SUNDRY NOTICES AND REPORTS ON WELLS

8. Well Name and No
James Ranch Unit #109H

BOPCO, L.P. would like to utilize an armored, 3", 5000 psi WP flex hose for the choke line in the drilling of the well. This is rig equipment and will help quicken nipple up time thus saving money without a safety problem. The hose itself is rated to 5000 psi and has 5000 psi flanges on each end. This well is to be drilled to 14,244' MD (7680' TVD) and max surface pressure should be +/- 1690 psi as prescribed in onshore order #2 shown as 0.22 psi/ft. Thus, 2000 psi BOPE (for 12-1/4" hole) and 3000 psi BOPE (for 8-3/4" and 6-1/8" hole) is all that is needed for this well.

Latshaw Drilling
RIG 4
CHOKE MANIFOLD

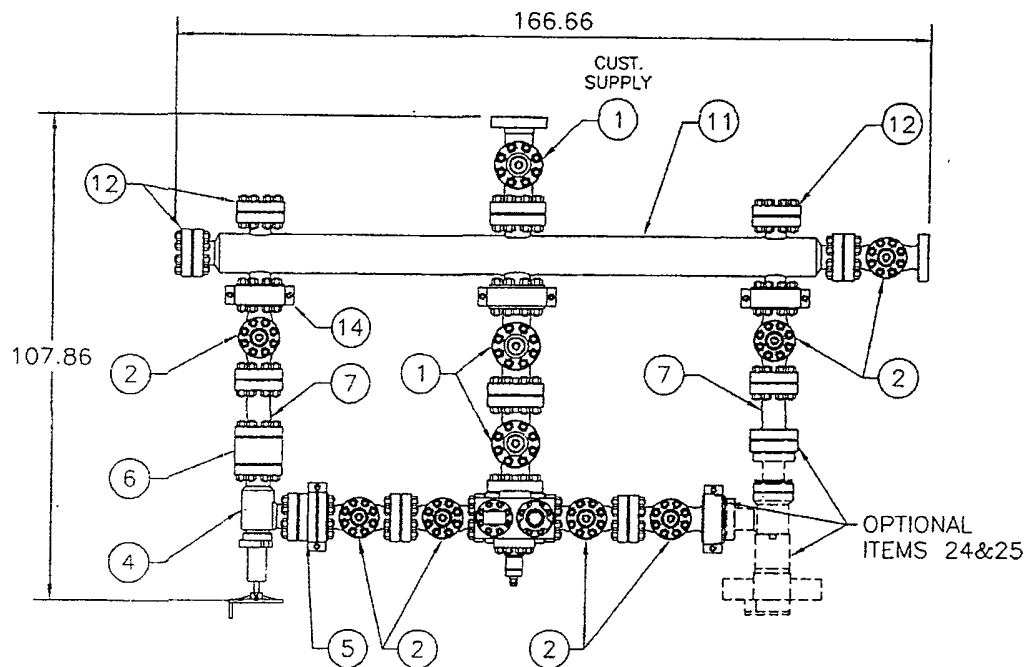
The Latshaw #4 BOPE diagram (5000 psi as specified within the approved APD) is attached along with spec sheet and drawing of the 3-1/2" flex hose.
